# Safety Certification Audit Report Issued July 15, 2022

Project:	Security Audit Profiles 1000, 2000 & 3000 Safety Audit Profile 3000			
Audit Type:				
PREPARED BY (T.	ALSON):			
Norman Jones – A		Date:	June 1, 2022	
KODEIL FUITOW —	Auditor		June 1, 2022	
APPROVED BY (T	ALSON):			
Kenneth Brzozow	rski – Project Manager	Date:	June 27, 2022	
ADDROVED FOR	ISSUE (SOUND TRANSIT):			
APPROVED FOR	1330E (300ND TRANSIT).			
Patrick Johnson –	- ST Director, Audit Division	Date:	July 12, 2022

Commencing in March and extending through May 2022, Talson Solutions, LLC (Talson) performed a desktop Safety and Security Certification Audit (SSCA) of the East Link Extension (ELE) Project for contract E340. The audit was performed on behalf of the Sound Transit Audit Division and focused on the following areas:

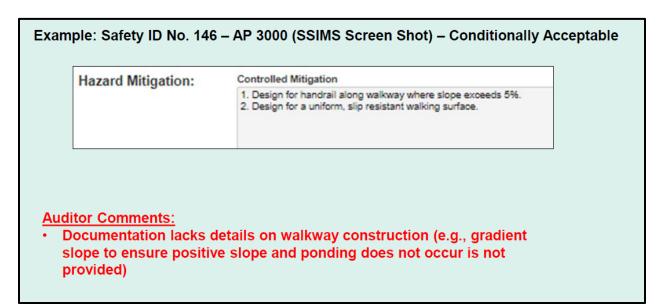
#### Example: Security ID No. 26 – AP 2000 (SSIMS Screen Shot) - Unacceptable Controlled Mitigation Install skateboard clips on surface edges, where appropriate, at stations to deter skateboarding / loitering. **Auditor Comments:** Suggested Construction Station railing was designed 42 inches high to Documentation Provide representative sam prevent skateboarding and armrests are to be ple of IDR & Photo Document part of seated benches. Further, the IDR 1/6/21 ation to show that the arm res t that act as skateboard deterr says it placed armrests on benches but only ents are constructed per E23provided photos of the railing. AEE010 to 012. Material submittals

Talson was unable to verify the design of benches (or if even benches were installed as

part of the hardscape plan)

**Observation No. 1:** SSIMs security certifiable item ID 26 did not have proper design documentation uploaded.
